Highland Falls – Fort Montgomery Central School District

James I. O'Neill Renovation Project

Addendum No. 3

September 28, 2021

HM-100
AD3

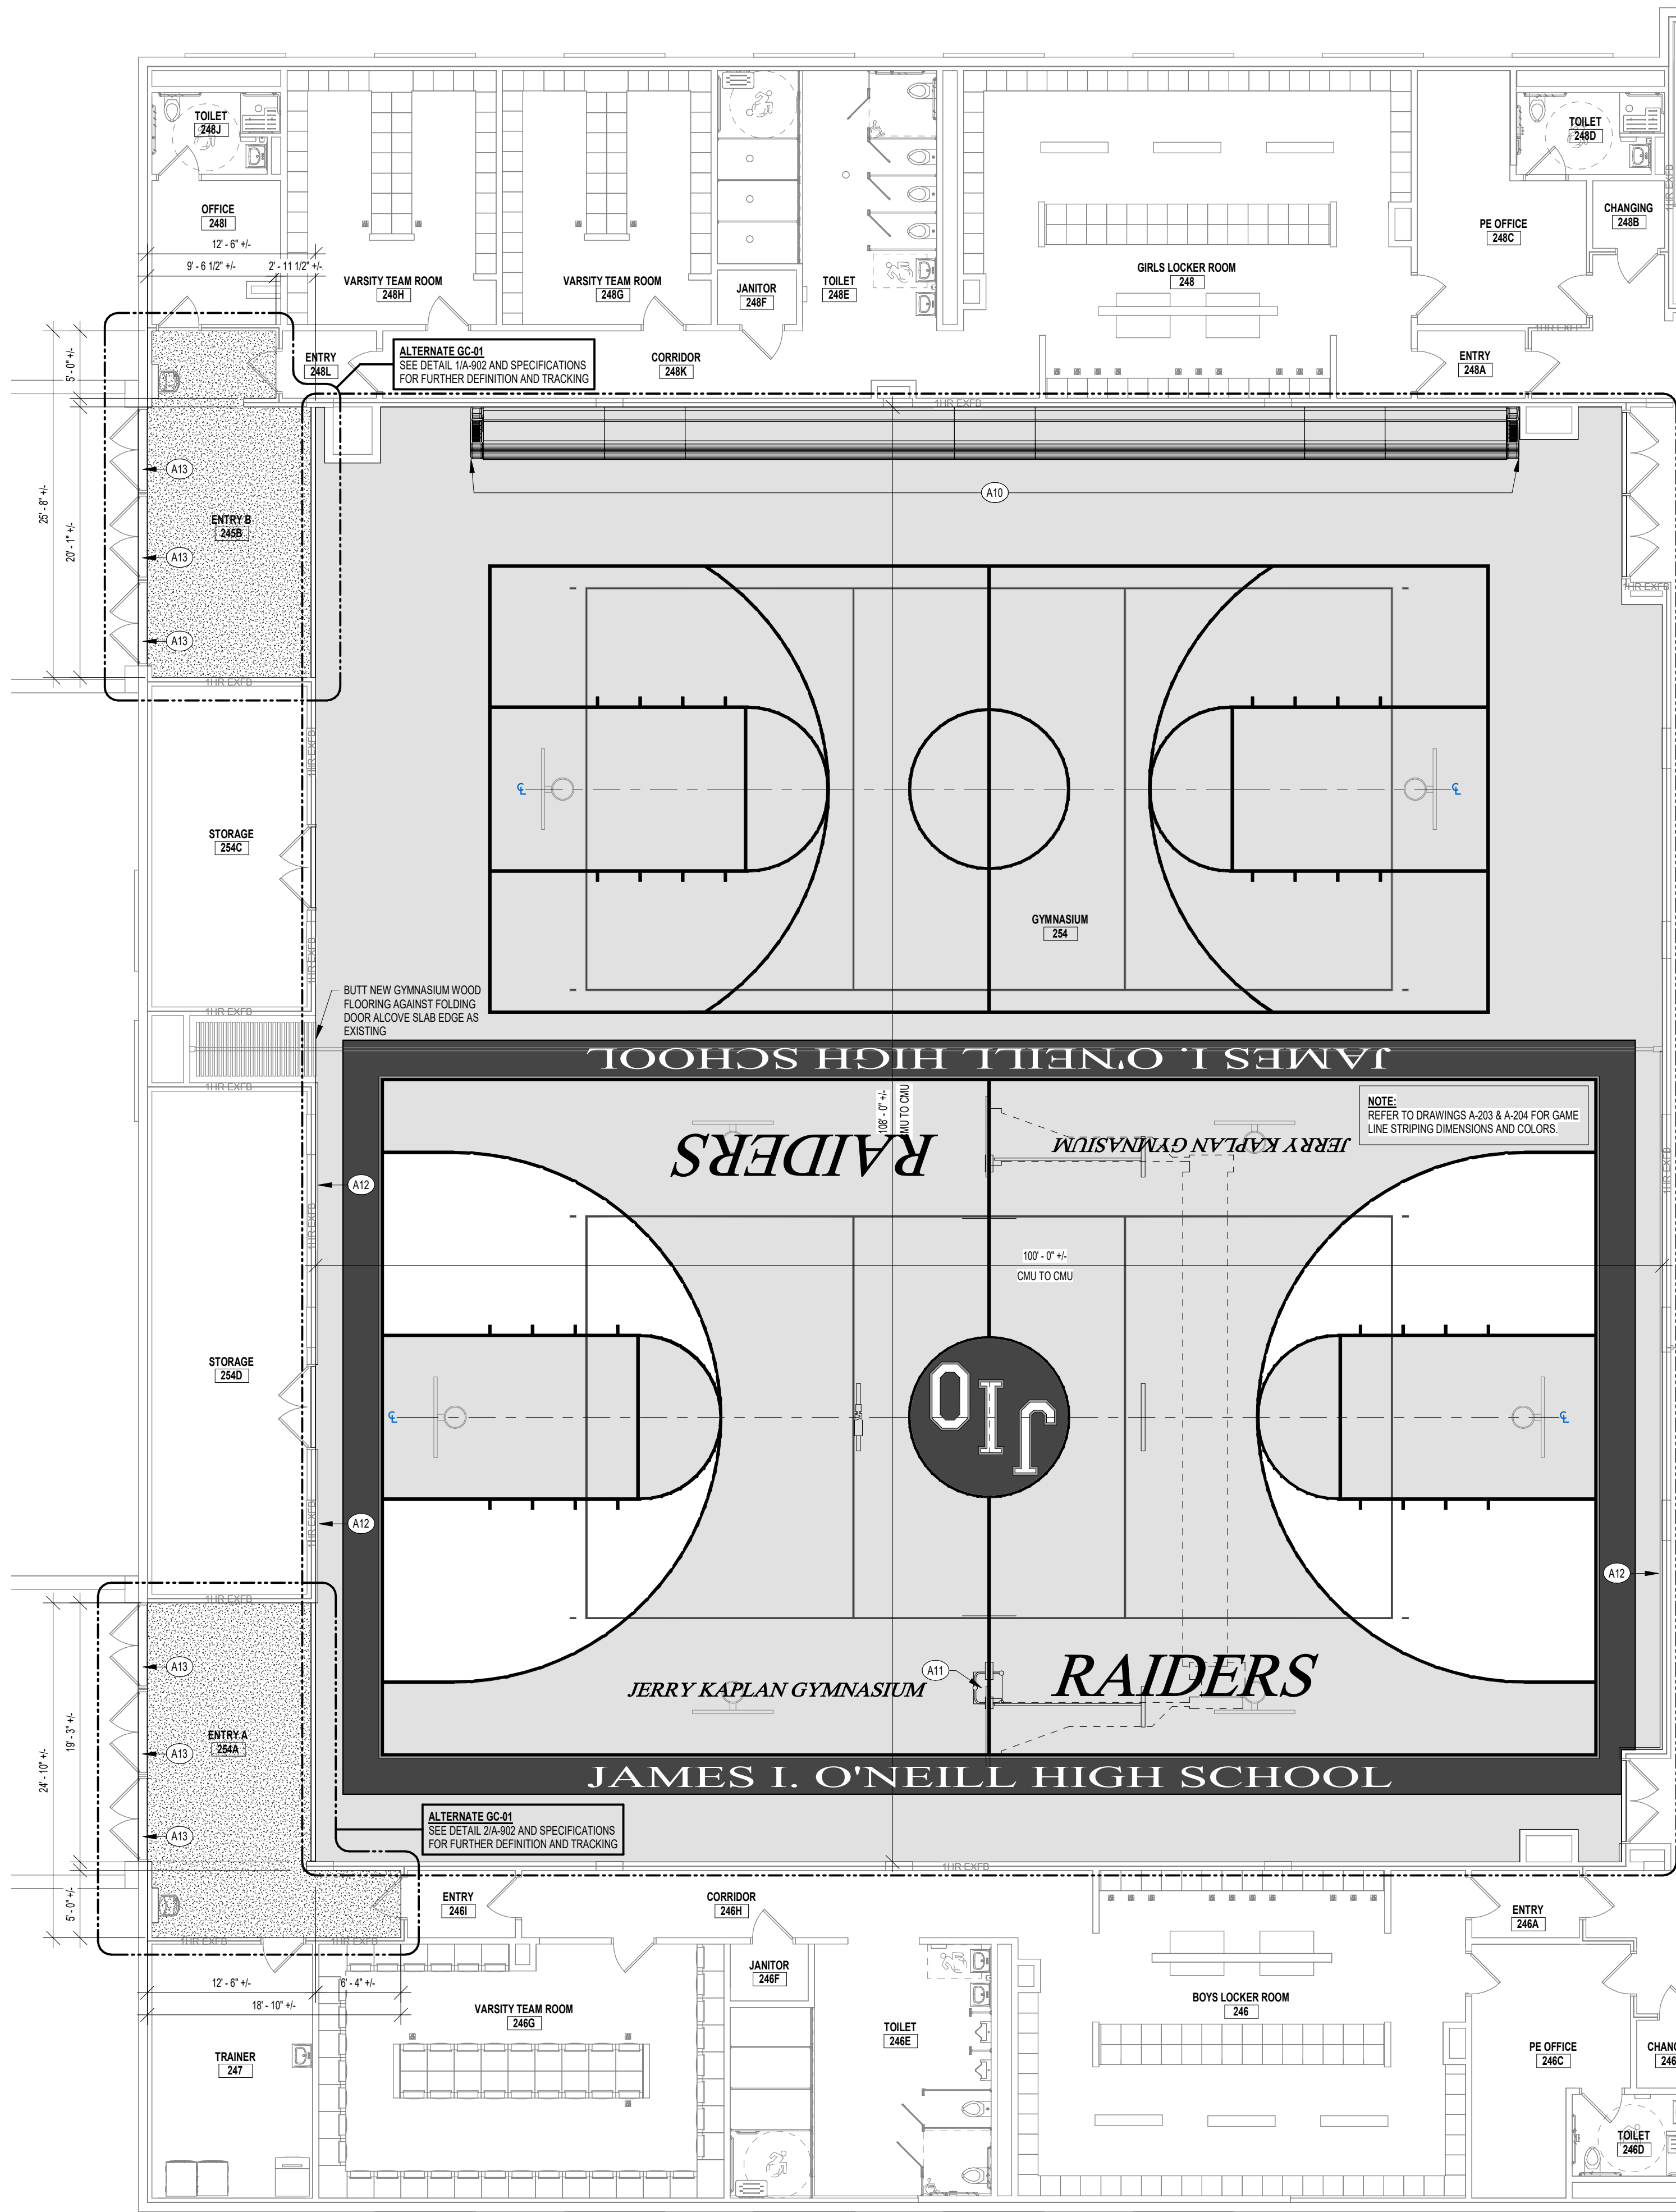
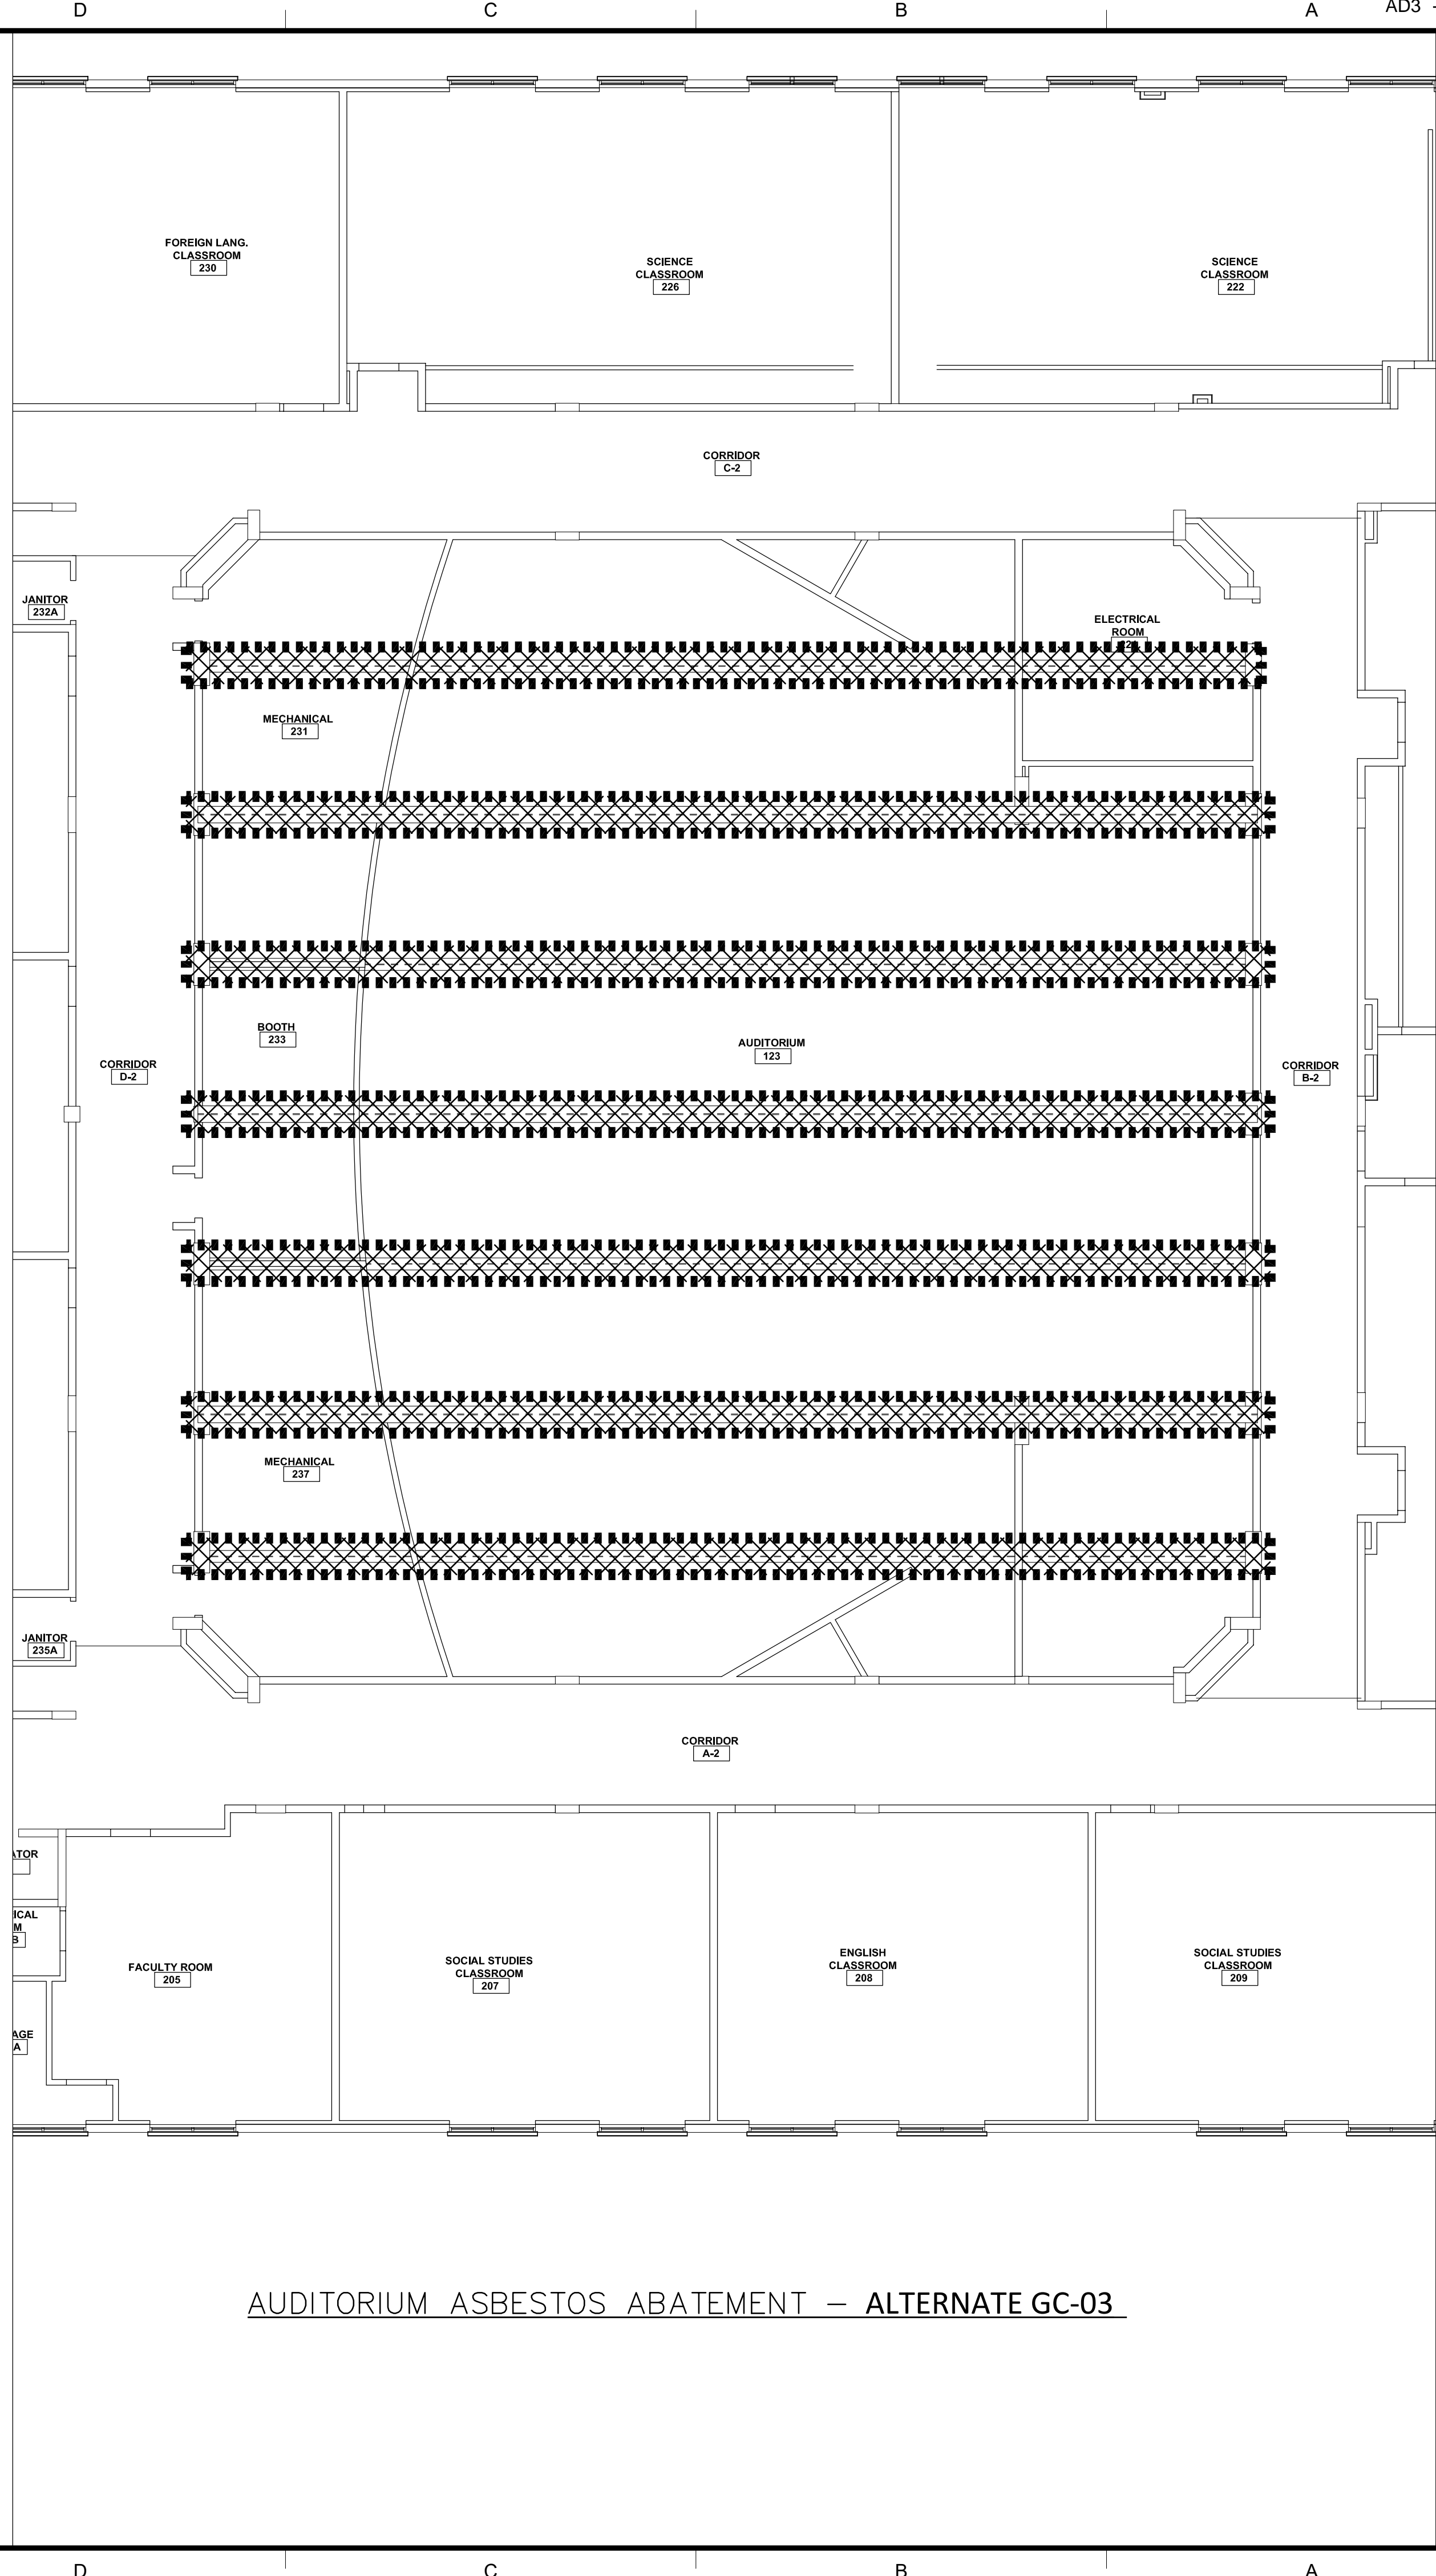
- A. Refer to Drawing HM-100 *Asbestos Abatement Plan – Area A*; **DELETE** in its' entirety and **REPLACE** with the attached drawing AD3/HM-100 *Asbestos Abatement Plan – Area A*.
- B. Refer to Drawing A-202 *Lift Landing Steel Structure and Marquee Details*; **DELETE** in its' entirety and **REPLACE** with the attached drawing AD3/A-202 *Lift Landing Steel Structure and Marquee Details*.
